# UNITED STATES PATENT AND TRADEMARK OFFICE

# Office Action Summary

10/800,867

**DETAILED ACTION**

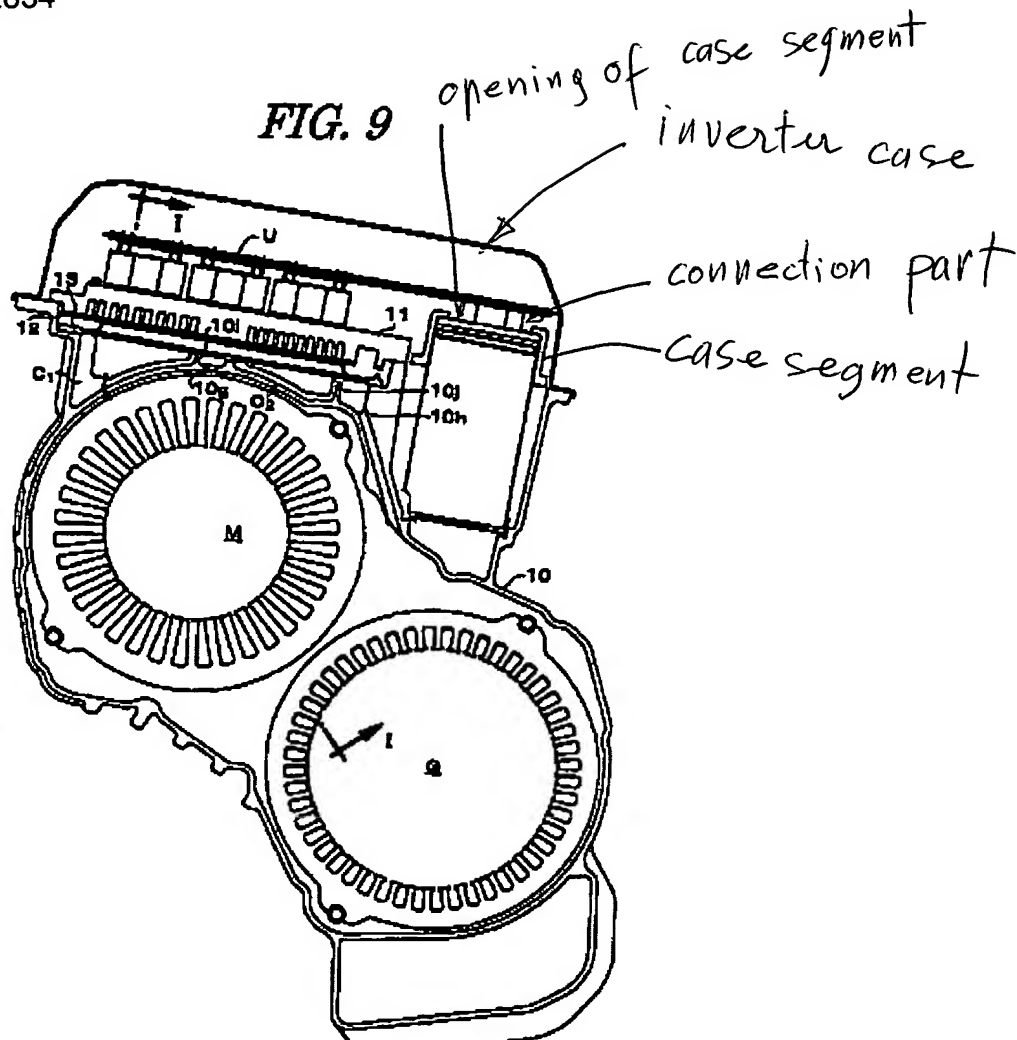
Regarding claims 15, 19 and 20, Hara et al. disclose a drive system wherein the electric power devices are connected to the respective inverters with connection parts (please see markups below) which extend out from the corresponding case segments.

Regarding claims 21 and 16, Hara et al. disclose a drive system wherein each of the connection parts has a terminal which extends through the corresponding case segment and which projects into the inverter case (Fig. 9).

Regarding claims 17 and 22, Hara et al. disclose a drive system wherein each of the terminals is positioned near an opening of the corresponding case segment.
